SUBJECT: Forwards changes to FSAR Chapter 13, modifying sys training
 for auxiliary operators, requiring license, certification &/or
 enrollment in approved requalification program for senior
 reactor operators & changing organizational titles.

Subject: Palo Verde Nuclear Generating Station (PVNGS)
Units 2 and 3
Changes to PVNGS FSAR (Chapter 13)
Docket Nos. STN 50-529/530
File: 85-056-026; G.1.01.10

Changes to PVNGS FSAR (Chapter 13)

APS NUCLEAR ORGANIZATION
Figure 13.1-2

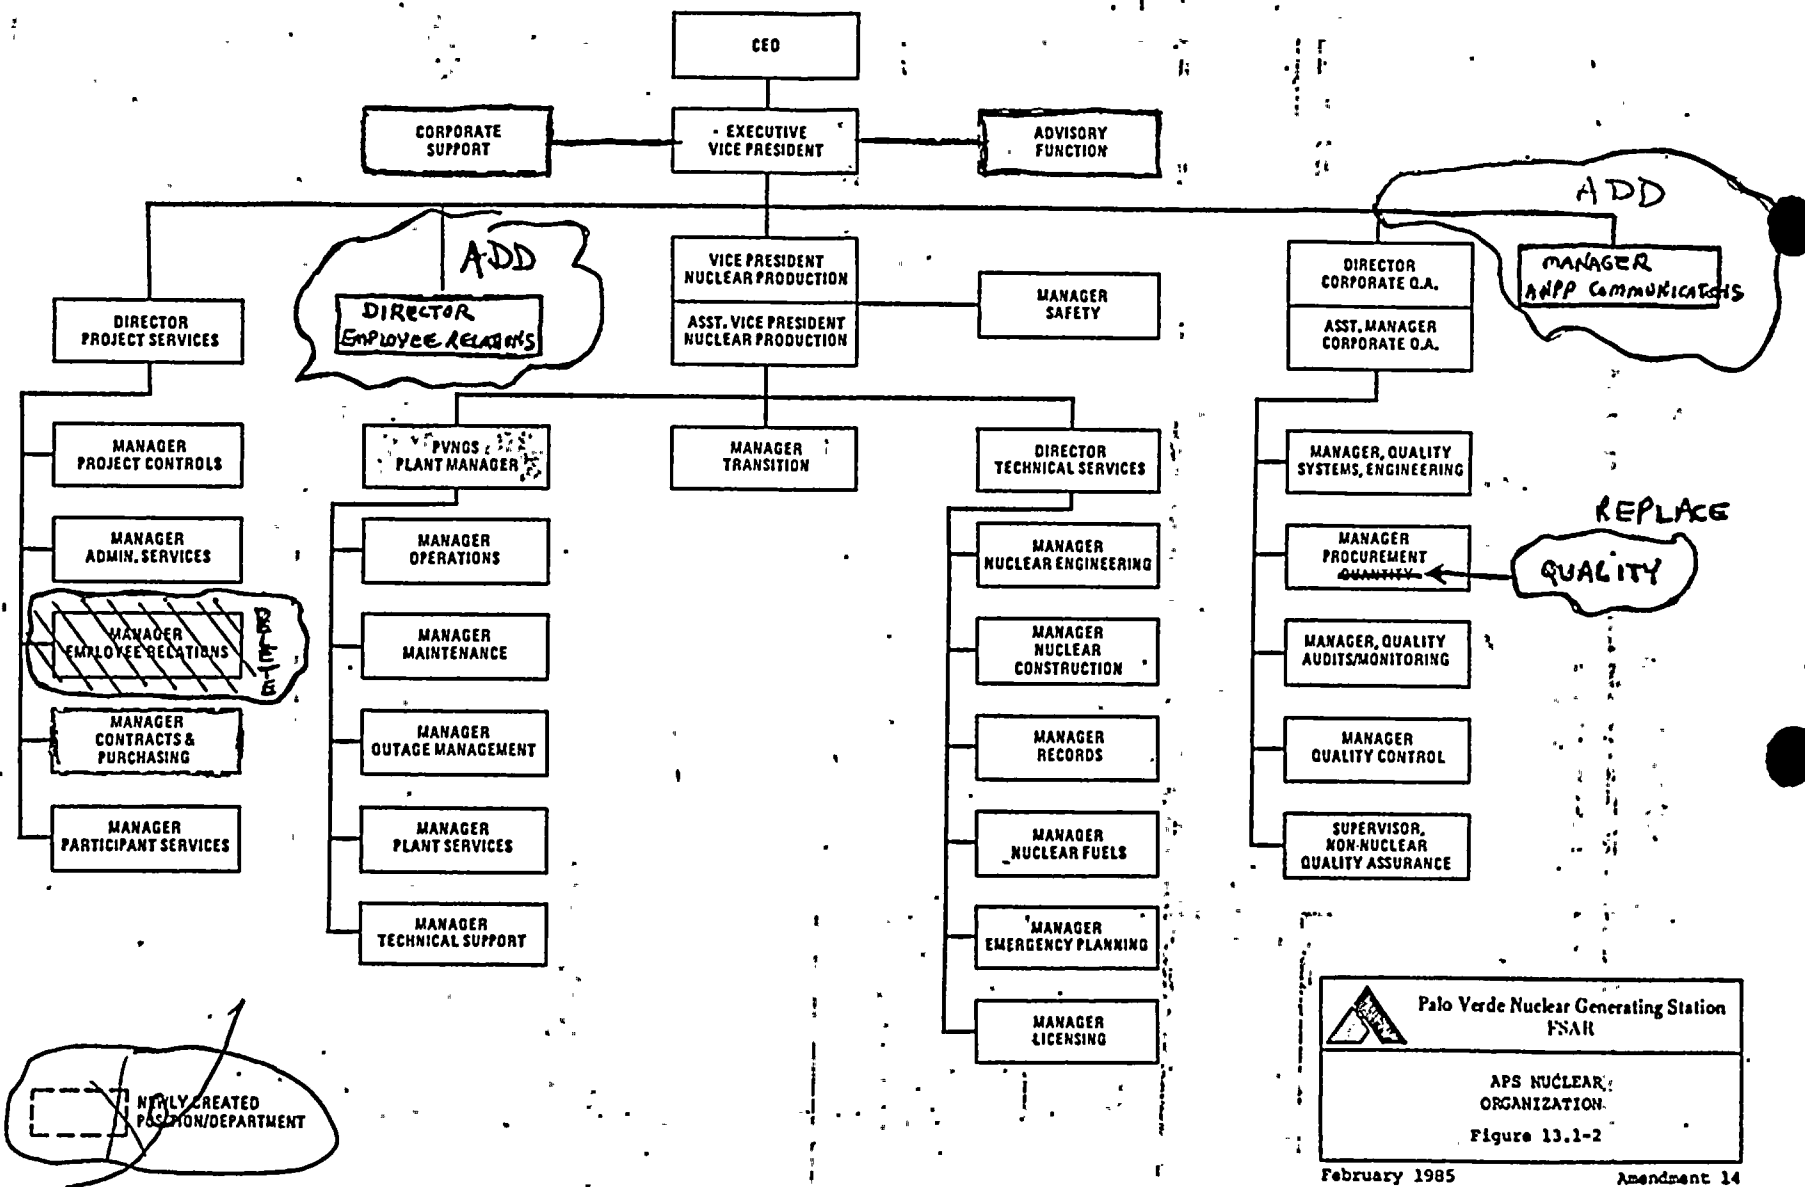
The Vice President-Nuclear Production, through the Executive Vice President of Arizona Nuclear Power Project (ANPP), has been designated by the ~~President~~ ^{Chairman, Board of Directors} and Chief Executive Officer of APS as the Corporate Officer responsible for providing management and technical support services for PVNGS (refer to figure 13.1-1). The Vice President-Nuclear Production has established under him departments and staff sections as discussed in section 13.1.1.2.2 and as shown on figure 13.1-2.

The Director, Project Services is assisted in the performance of duties by the following departments which report directly to him (Refer to figure 13.1-2B):

Palo Verde Nuclear Generating Station
FSAR
APS NUCLEAR
TECHNICAL SUPPORT
Figure 13.1-6A

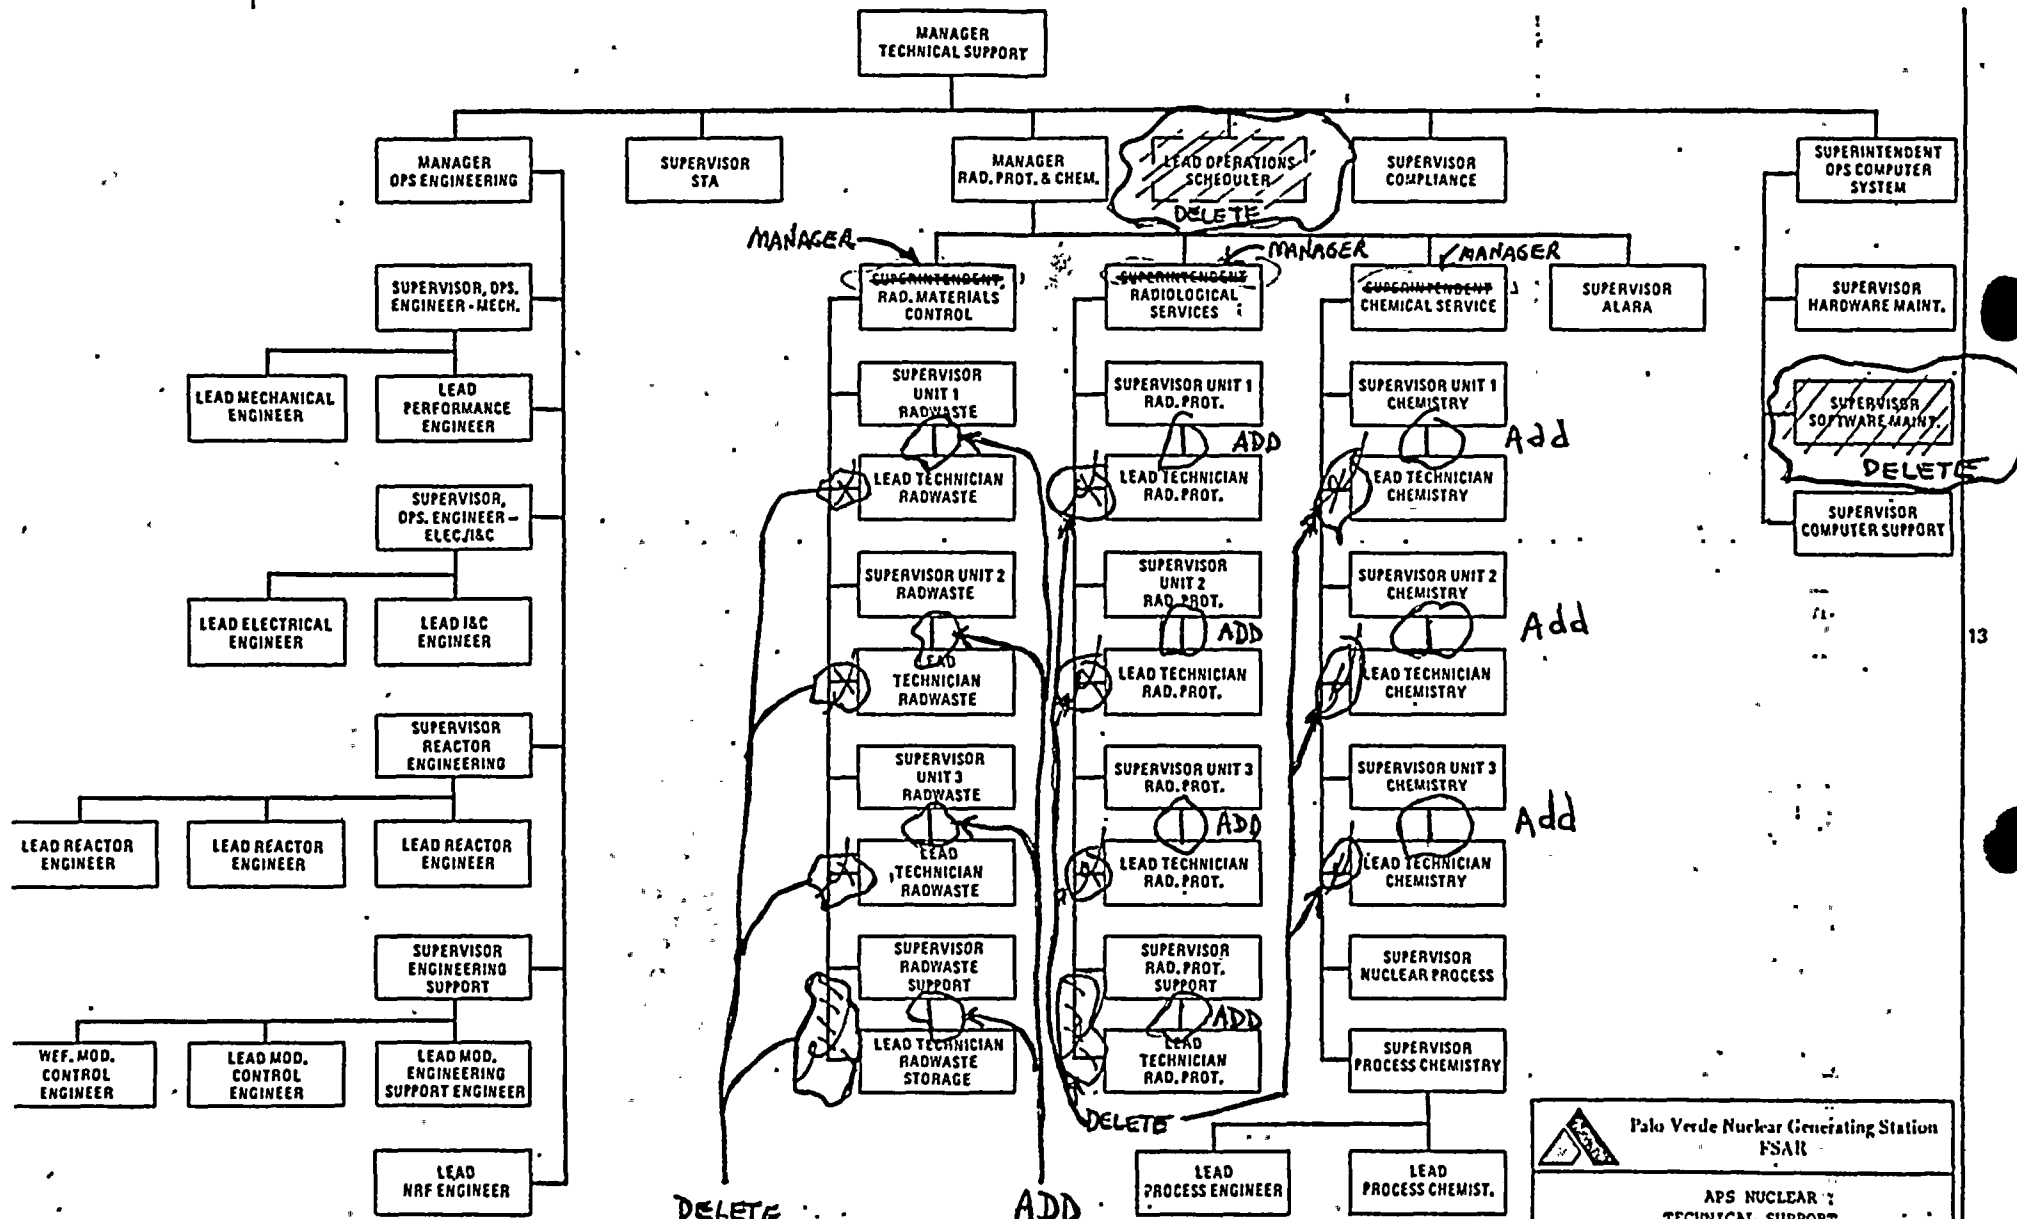
The Technical Support Manager is responsible to the PVNGS Plant Manager for the technical support required to ensure proper functioning of the nuclear plant. He directs the Manager of Engineering, Manager of Radiation Protection and Chemistry, Supervisor of Compliance, ~~Supervisor~~ ^{Manager} of Computer Systems, ~~Operations Schedule~~ and the Shift Technical Advisor Supervisor in the performance of their duties (Refer to Figure 13.1-6A).

13.1.2.2.2.1 ^{OPERATIONS} Engineering Manager. The ^{OPERATIONS} Engineering Manager is the department head responsible to the Technical Support Manager for Onsite Engineering and technical work required for proper operation of the nuclear plant. He directs the supervisors of the onsite nuclear and operations engineering in the performance of their duties.
